Access Compliance Report Public Rights-of-Way (Curb Ramps)

Intersection ID: 10023160 Main Street: CHARLOTTE_VIEW_DR Cross Street: N/A Location: S

ADA ID: B5AED1C7E798 Ramp Type: Perp Initial Pass/Fail: Fail Overall Compliance: No Severity Score: 12.5

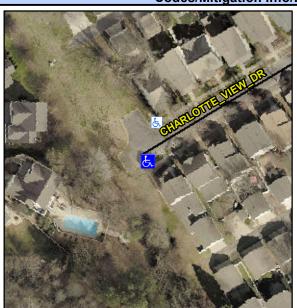
Not Found, R304.2.2

Fleid Measurements/Component Compliance							
Compliance Description		Data	Compliance Description		Data		
N/A	Ramp Length (in)	60.0	No	Ramp Slope (%)	11.6		
Yes	Ramp Width (in)	48.0	Yes	Ramp XSlope (%)	1.8		
N/A	Flare Type LT	N/A	N/A	Flare Type RT	N/A		
N/A	Flare Slope LT (%)	N/A	N/A	Flare Slope RT (%)	N/A		
N/A	Flare Traversable LT?	N/A	N/A	Flare Traversable RT?	N/A		
N/A	Landing Length (in)	N/A	N/A	DWS Provided?	N/A		
N/A	Landing Width (in)	N/A	N/A	DWS Contrast?	N/A		
N/A	Landing Slope (%)	N/A	N/A	DWS Length (in)	N/A		
N/A	Landing X Slope (%)	N/A	N/A	DWS Full Width?	N/A		
N/A	Landing Curb? (Y/N)	N/A	N/A	DWS Offset (in)	N/A		
N/A	Shared Landing?	N/A					
N/A	Gutter Ponding?	N/A	N/A	Gutter Slope (%)	N/A		
N/A	Gutter Lip Ht (in)	N/A	N/A	Gutter X Slope (%)	N/A		
N/A	Painted X Walk1?	No	N/A	Painted X Walk2?	N/A		
	X Walk 1 Direction	To N		X Walk 2 Direction	N/A		
N/A	X Walk 1 Width (in)	N/A	N/A	X Walk 2 Width (in)	N/A

Remove & Replace Entire Ramp.
